VILLAGE OF GERMANTOWN
N112 W17001 MEQUON ROAD, GERMANTOWN, WI 53022

MEETING:	PLAN COMMISSION
DATE AND TIME:	MONDAY, September 9, 2019 6:30 p.m.
LOCATION:	Germantown Village Hall Board Room

GRAPHIC SCALE
0 30 60 120
(IN FEET)
1 INCH = 60 FT.

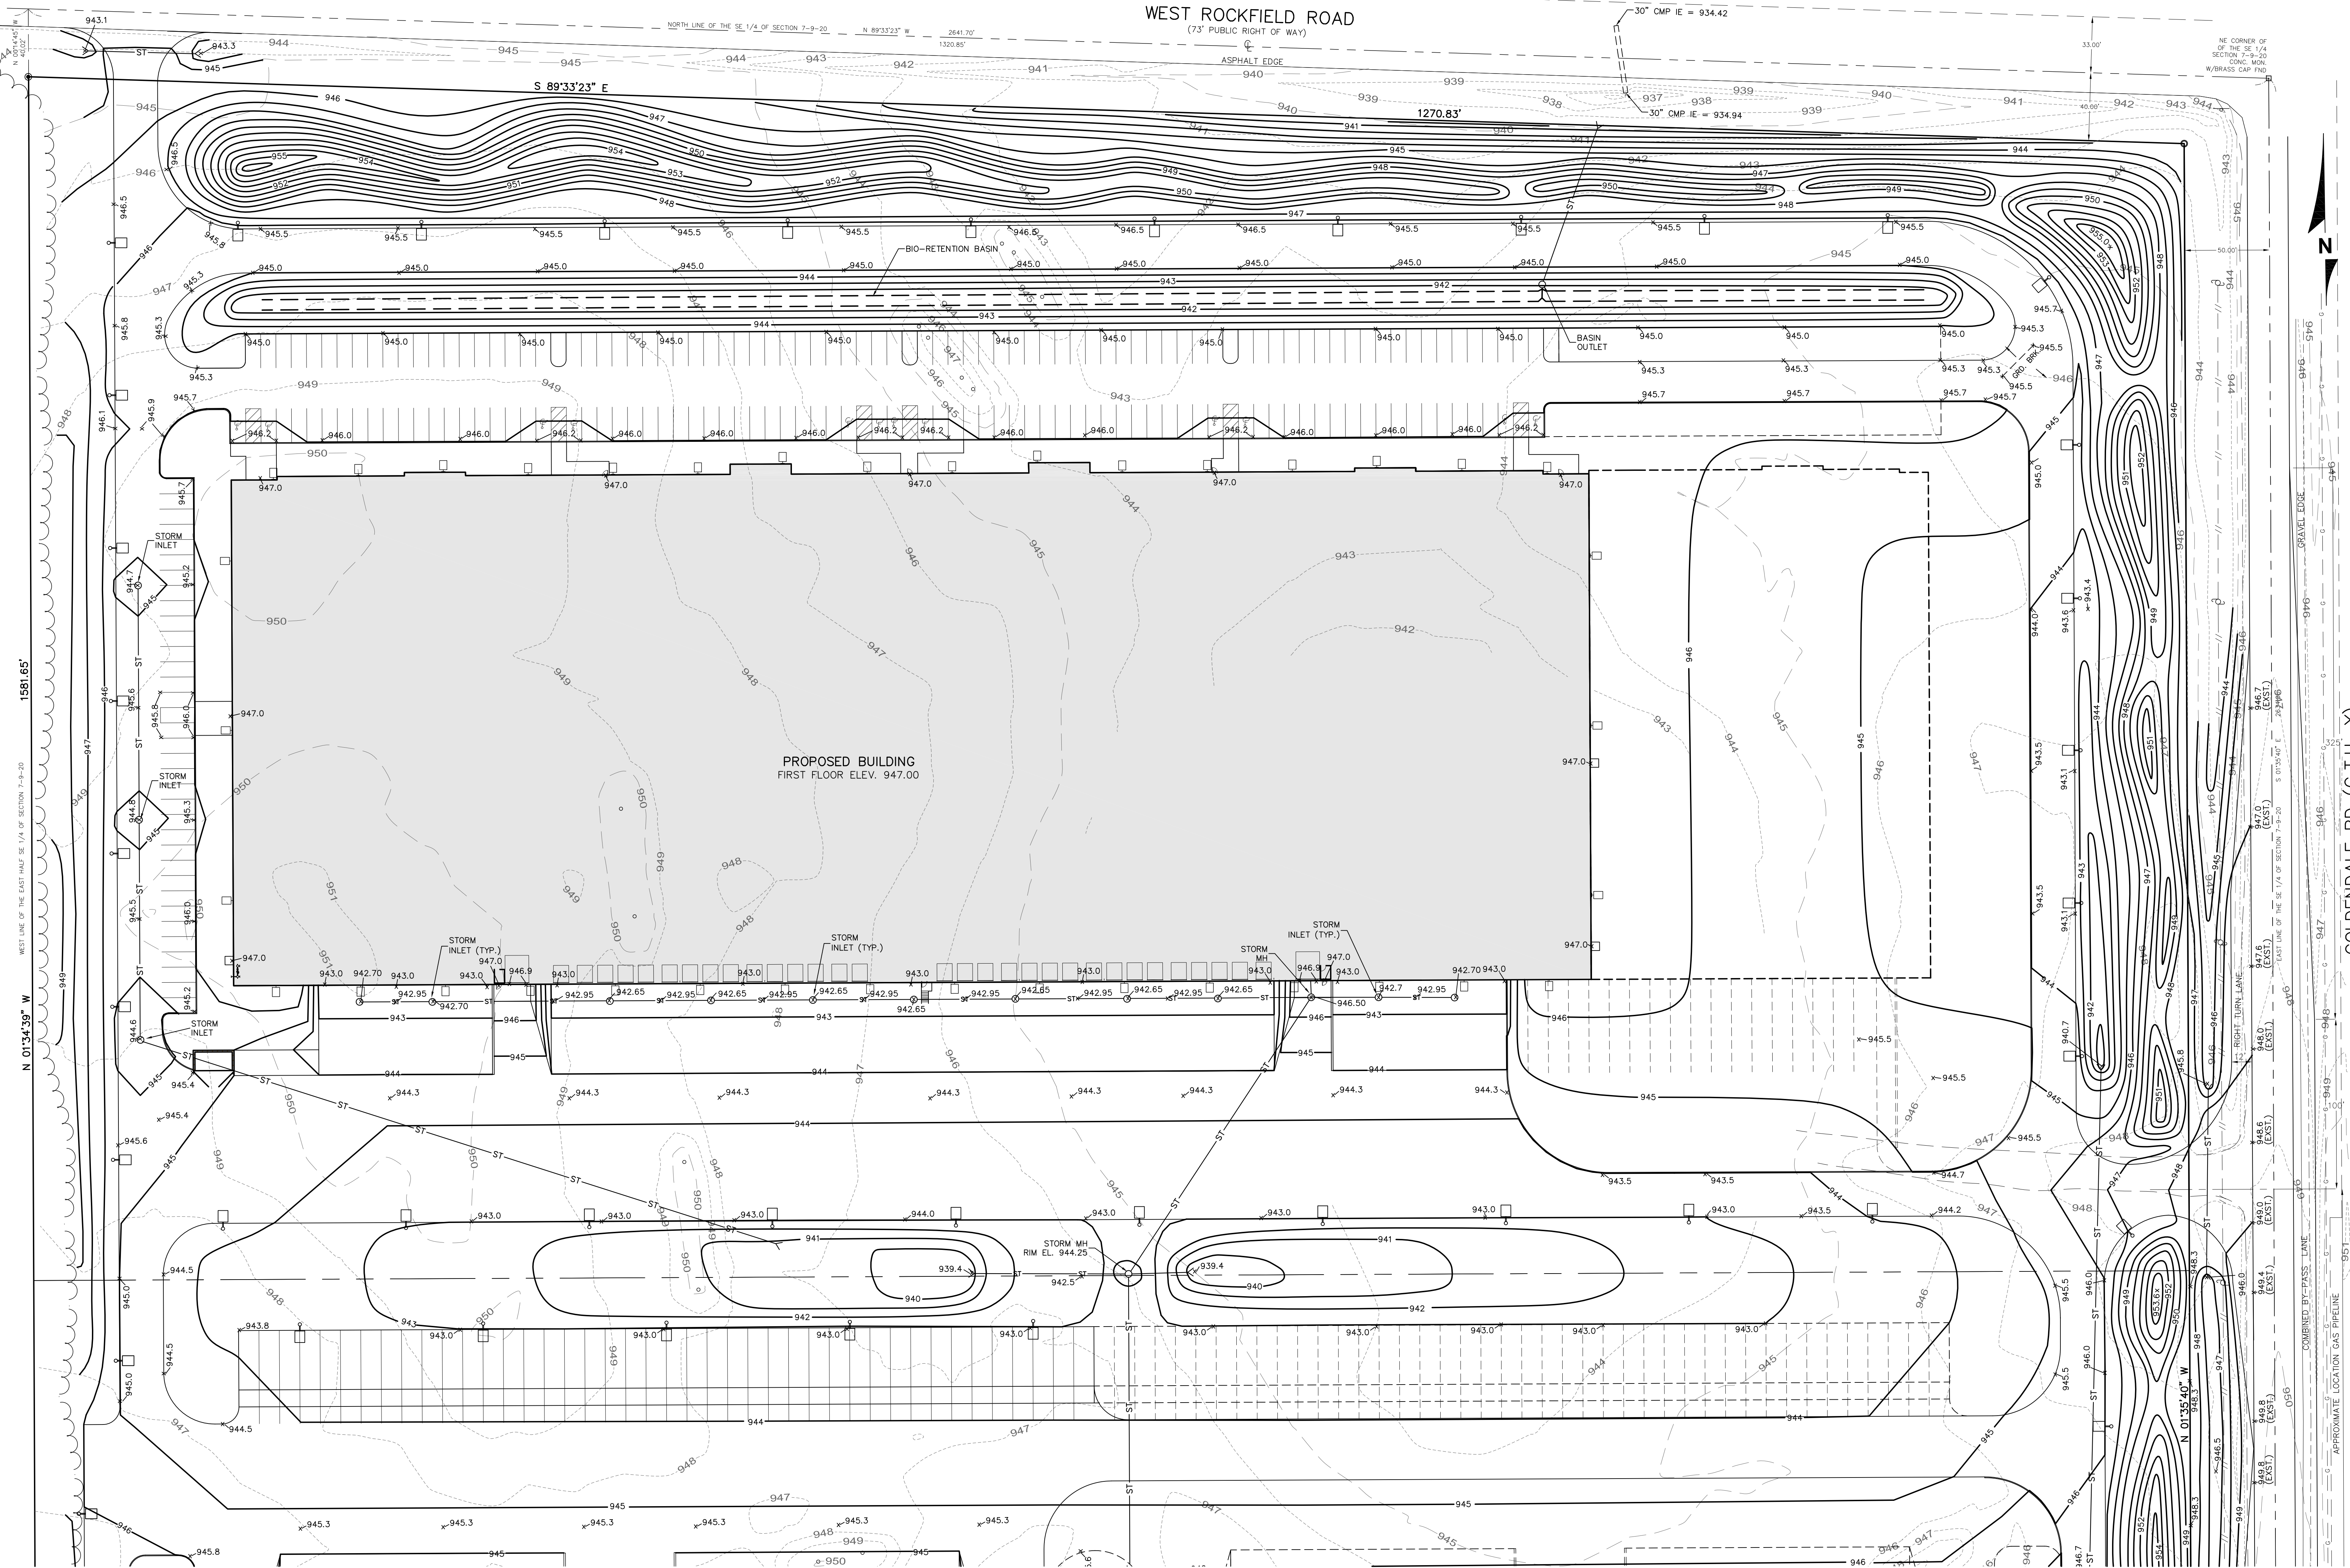
- *A dimensioned site plan is provide by the Architect, see sheets A0.1, A0.2 & A0.3*
10. Provide an exhibit showing a WB-67 can turn into through and exit the site. Adjust driveways and radii as required.

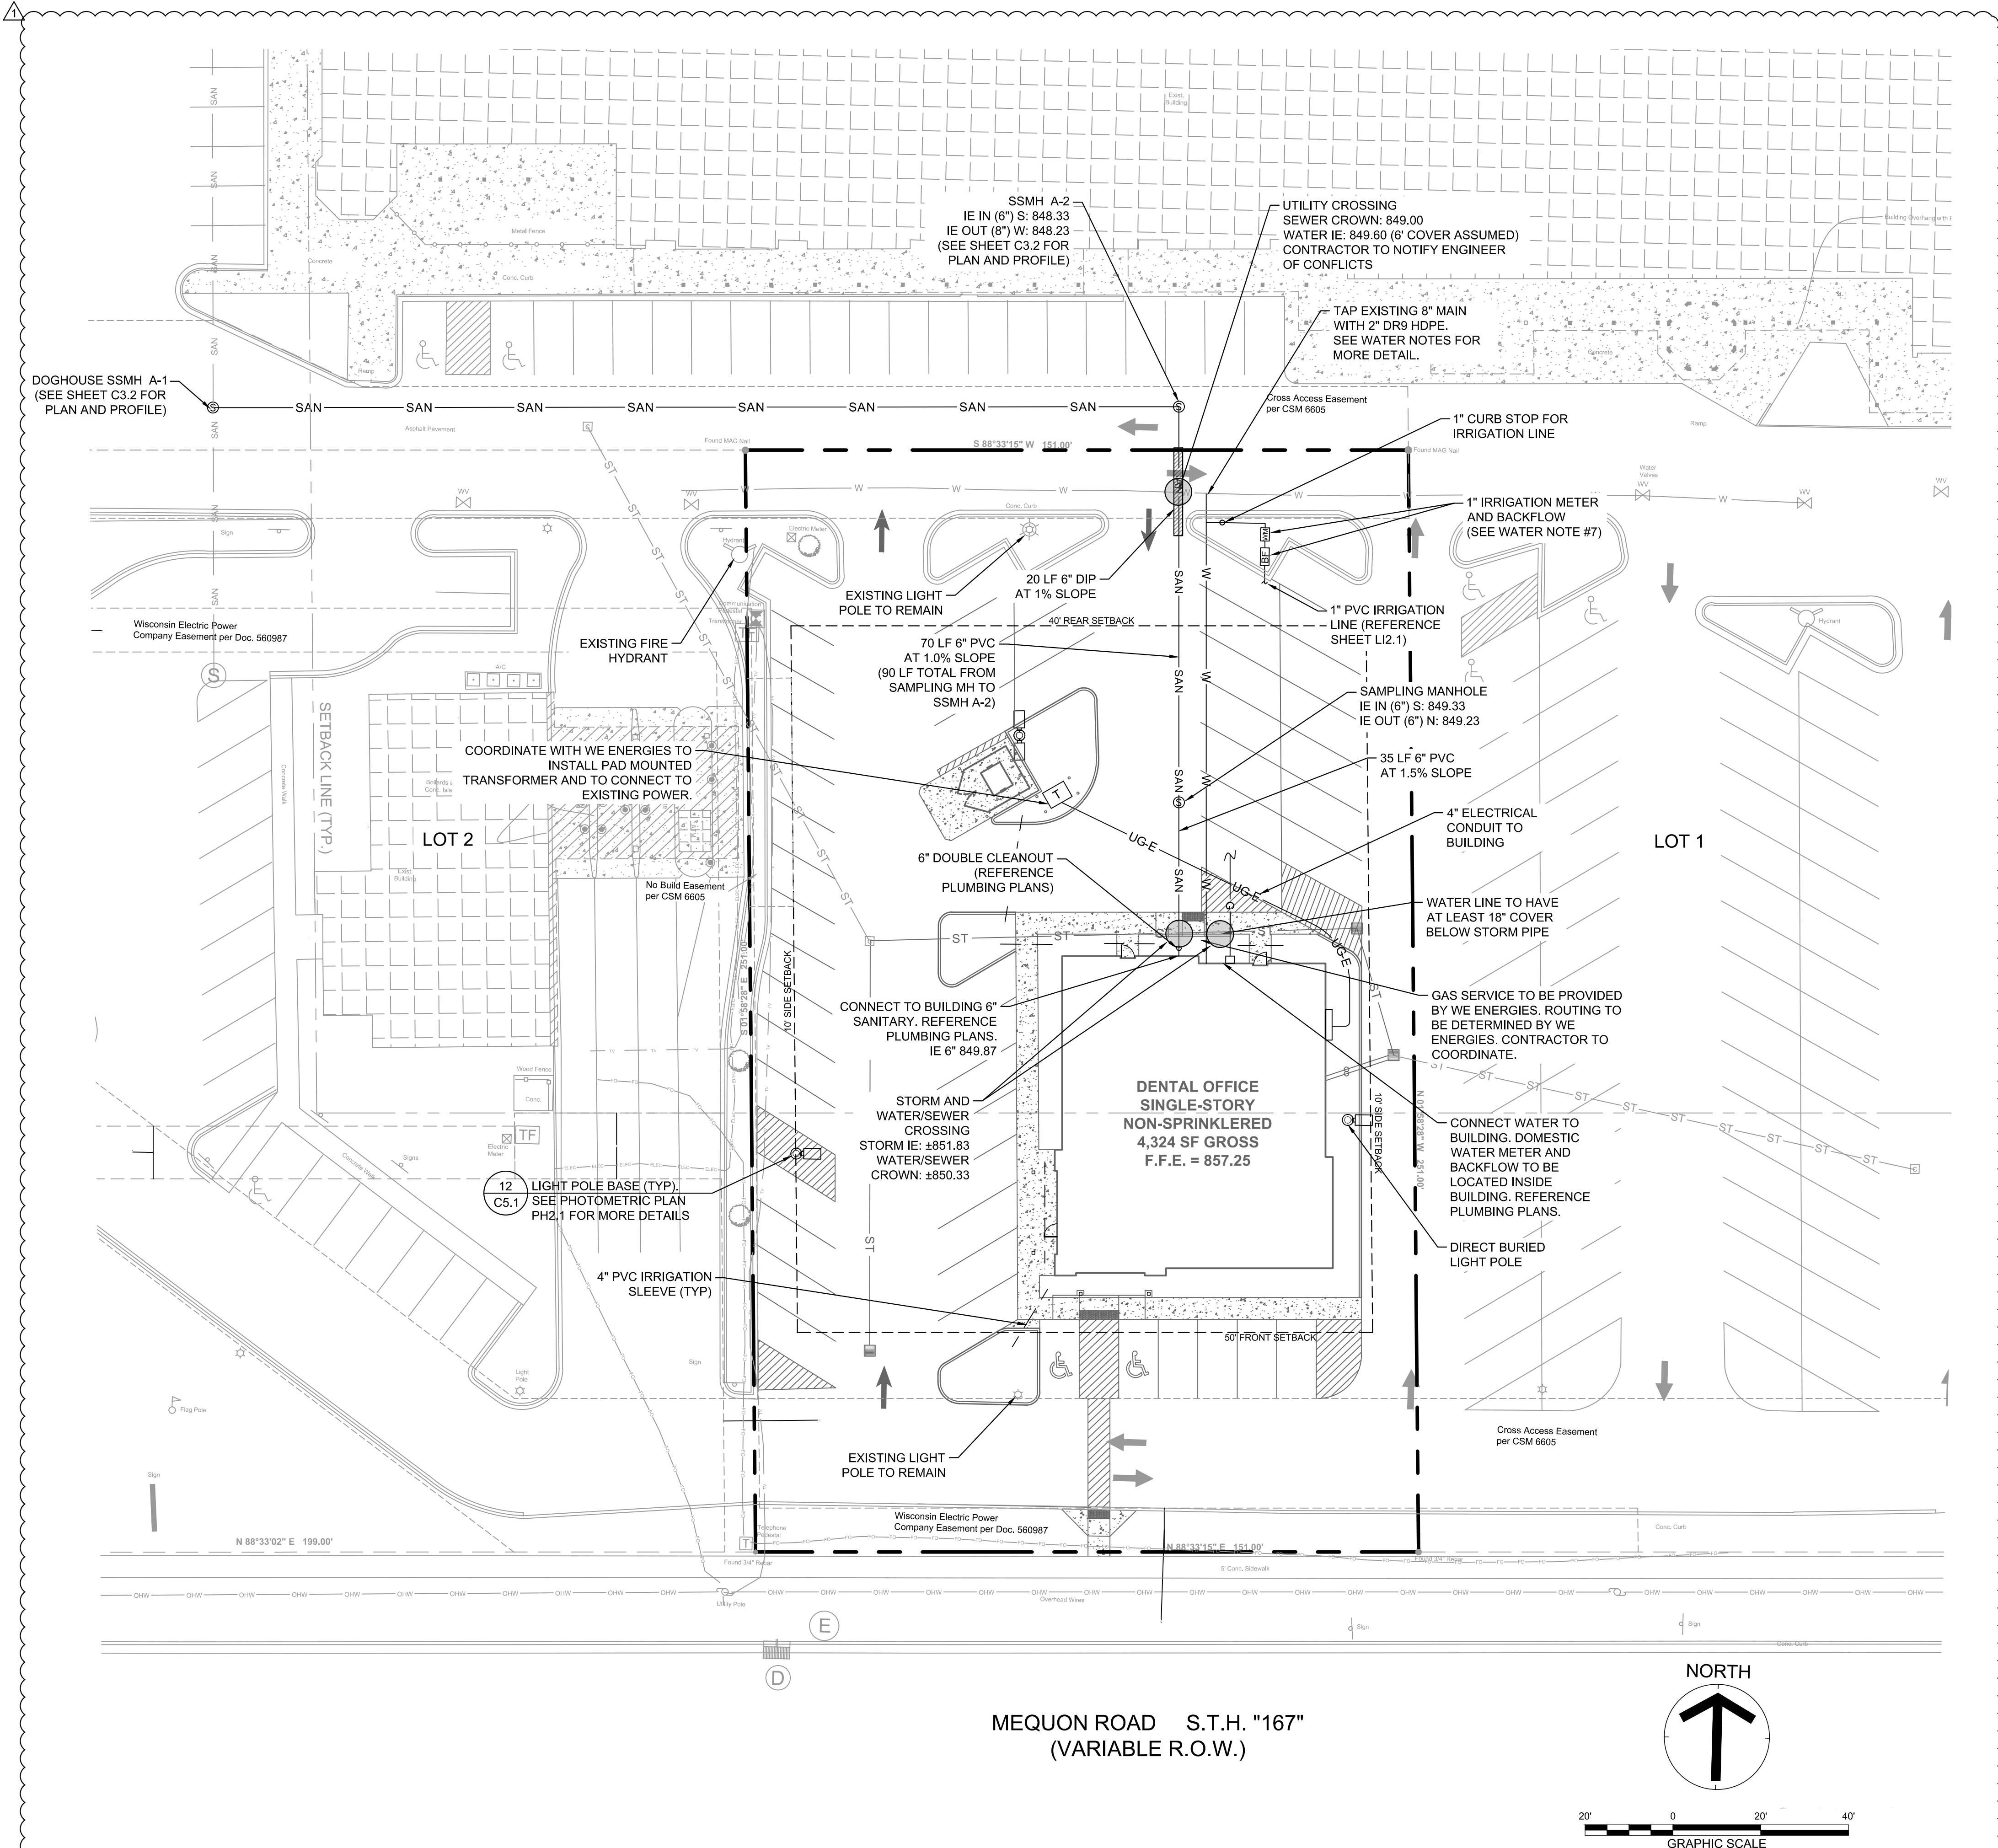
Response: *The note has been revised to reference WDNR standards.*
19. **Comment:** C3.1 Utility Plan: Plans note 6" PVC sewer lateral, but cleanouts are noted as 4". Please revise.

Response: *The plans have been revised accordingly.*
20. **Comment:** C3.1 Utility Plan: Revise sanitary sewer. Move manhole A-2 further east so the lateral from the building can connect directly to the manhole without the bends and cleanout. Add a sampling manhole to the lateral. See attached plan markup for additional detail.

21. **Comment:** C3.1 Utility Plan: Connection to the existing watermain shall be made with a Smith Blair-repair clamp with a CC port.
Response: *A Water Notes section has been added to this sheet. Note #3 refers to the connection clamp.*

22. **Comment:** C3.1 Utility Plan: Connection to the watermain for the irrigation line shall be made with the same Smith Blair repair clamp.
Response: *This note has been added to Water Notes #4.*

23. **Comment:** C3.1 Utility Plan: Install tracer wire per Village Standards (see attached).
Response: *This note has been added to Water Notes #5 and General Utility Notes #10. The specifications provided in the comment letter have been added to sheet C5.4.*

24. **Comment:** C3.1 Utility Plan: Install a separate curb stop for the irrigation line.
Response: *A curb stop for the irrigation line has been added to the plans.*

25. **Comment:** C3.1 Utility Plan: If the irrigation meter is installed outside it needs to be in a pit that allows for it to be removed and installed from above ground with separate shut offs for the inlet and outlet. Alternatively the meter could be installed inside with a lateral back outside.

Response: *A Mueller (or approved equal) water pit has been added to the plans. A detail for the water pit has been added to sheet C5.4.*
26. **Comment:** C3.1 Utility Plan: Water lateral shall be DR 9, please revise note #11.

SDD 8a5-b Inlet Covers Type B, B-A, C, MS, MS-A, and WM

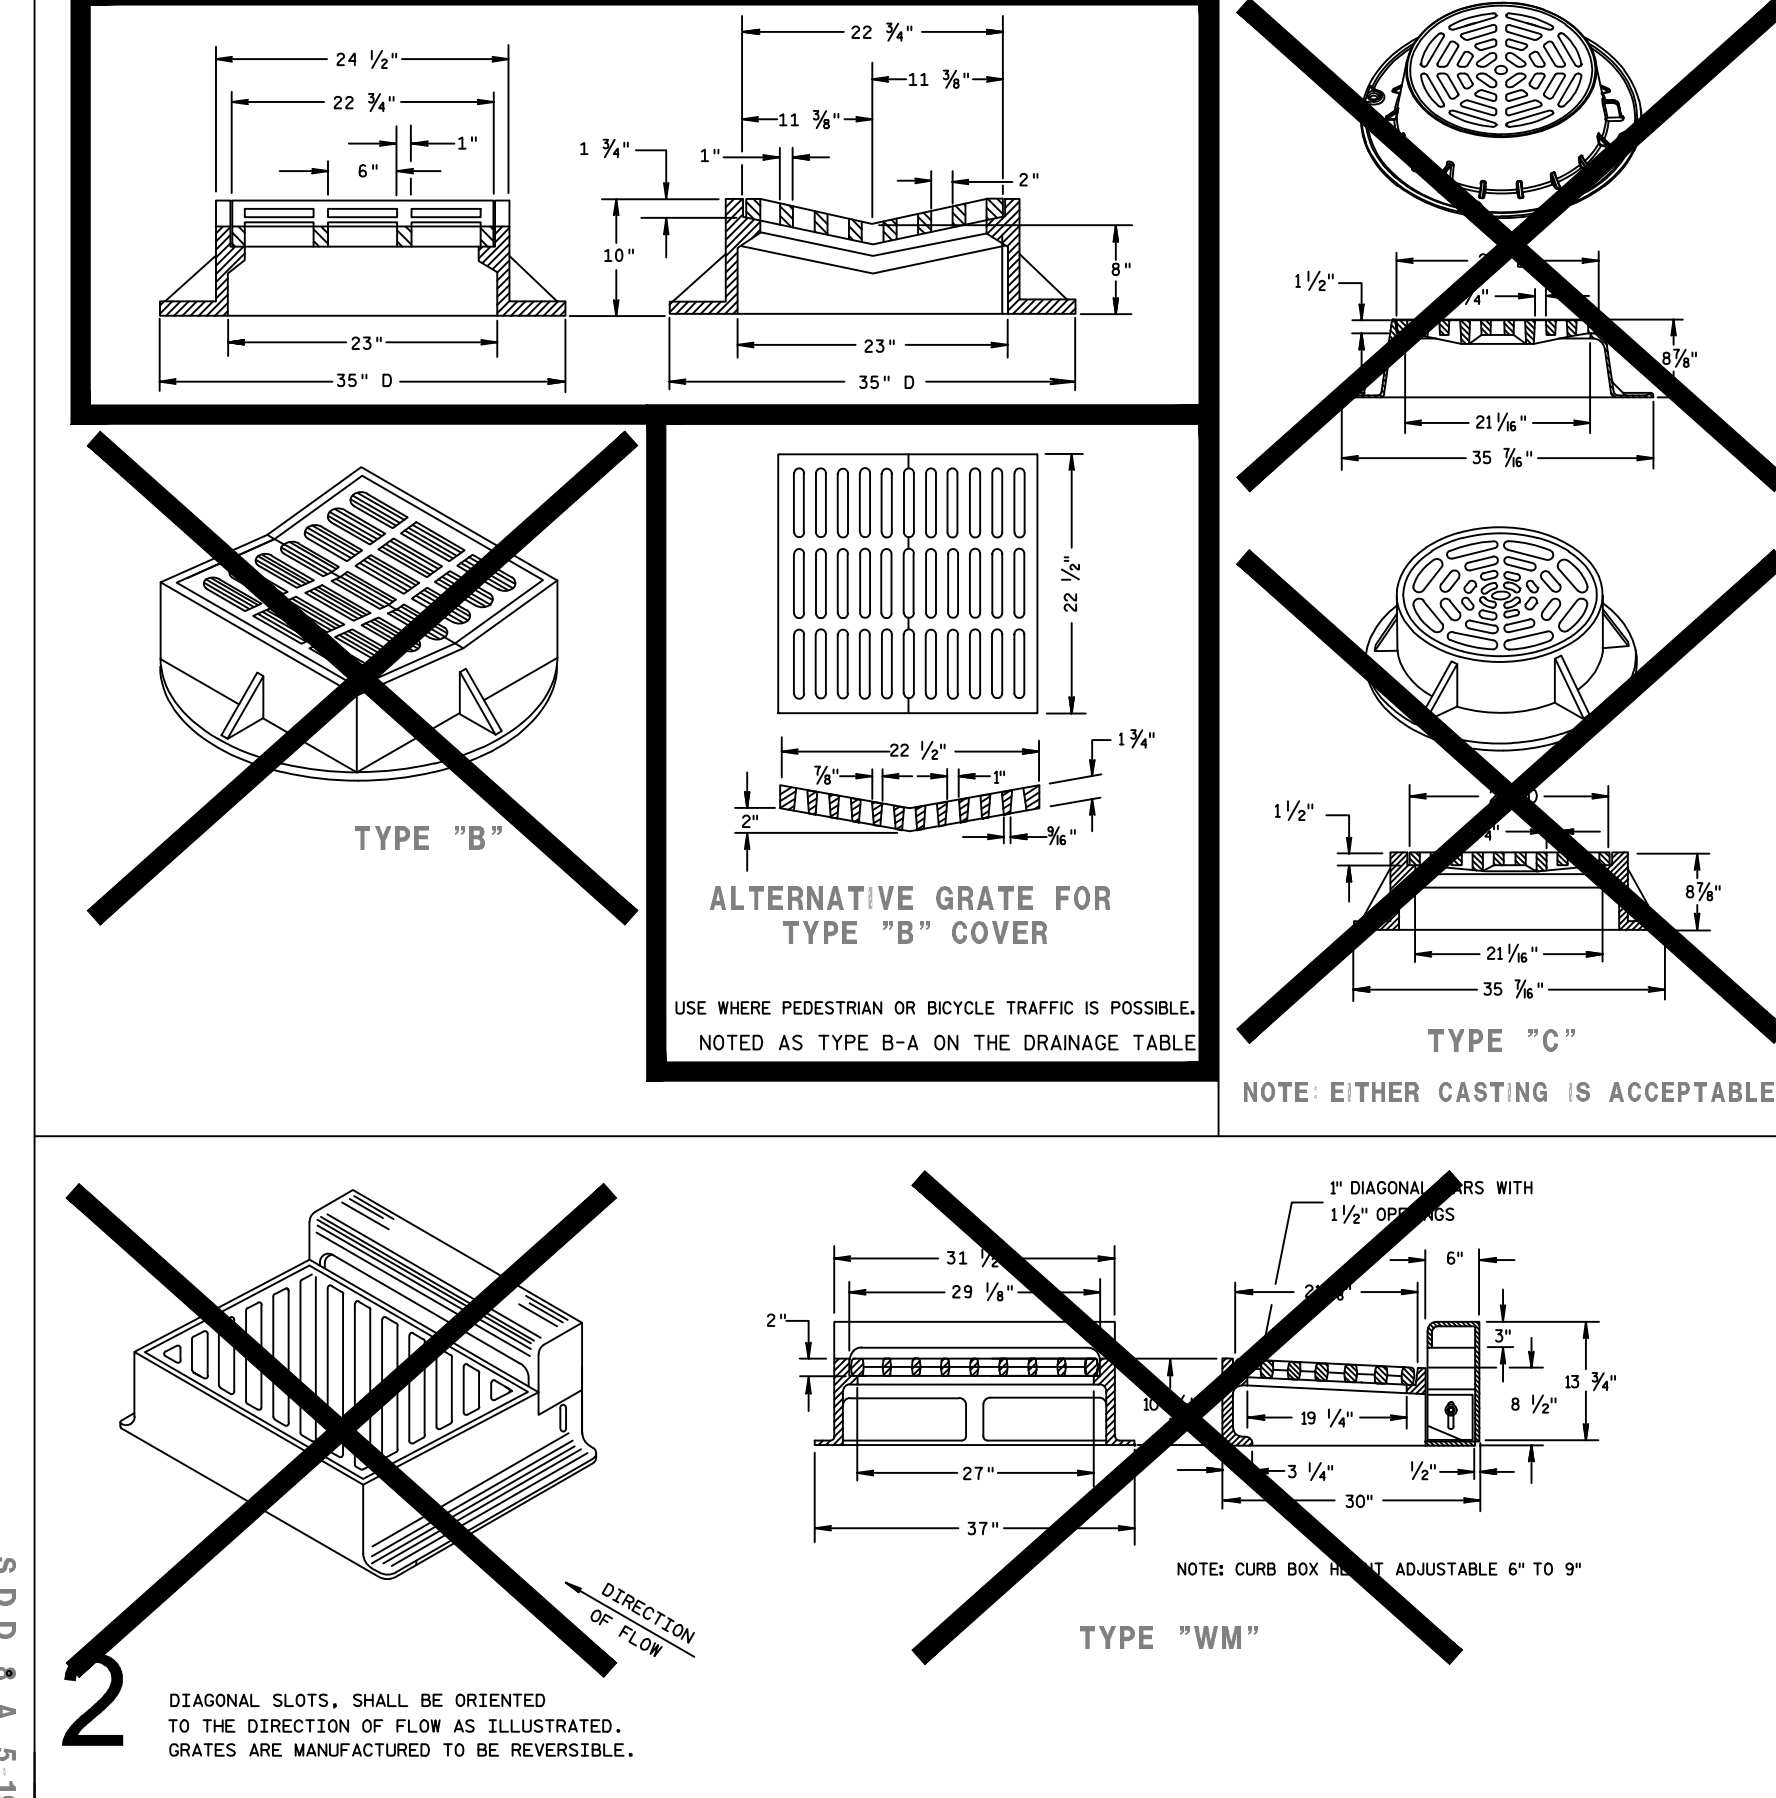
33. Comment: C5.3 Details: Inlet cover detail shows a number of different types of inlet covers. Please clarify which ones will be used on this project.
